**RE: Sunset Gardens Response to TRC Planning Comments - PD2024-00008**

Re: Sunset Grove (4945 Edwards Road)  
Response to Traffic Impact Analysis Comments  
TMC Project № 24203.03  
Fort Pierce, Florida

**RE: TECHNICAL REVIEW PROJECT: Sunset Gardens Master Planned Development- PD2024-00008**

**RE: 4945 Edwards Rd. Ft. Pierce. Sunset Gardens- Case #: PD2024-00008**

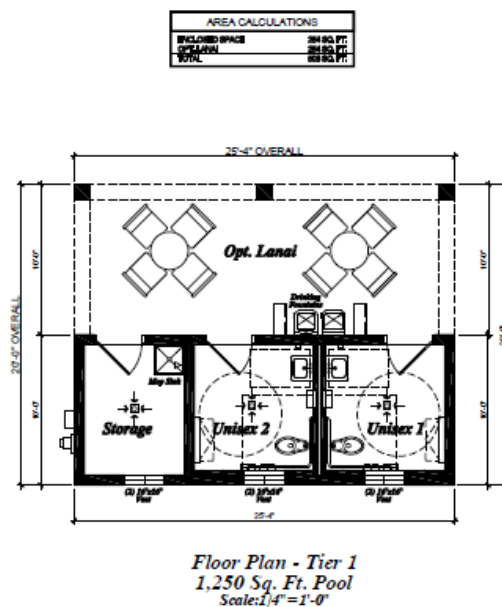
Development shall minimize paved areas, utilize porous paving materials and limit the use of curb cuts to reduce the amount of stormwater runoff and demand on the City's storm drainage system.

The Sunset Gardens PUD has been designed with one entrance into the development, thereby limiting the number of curb cuts to one. Additionally, the site has been designed for the drainage to flow to the centrally situated lake that connects to two retention ponds and the 3.48-acre wetland to provide a natural system of stormwater drainage for the community.
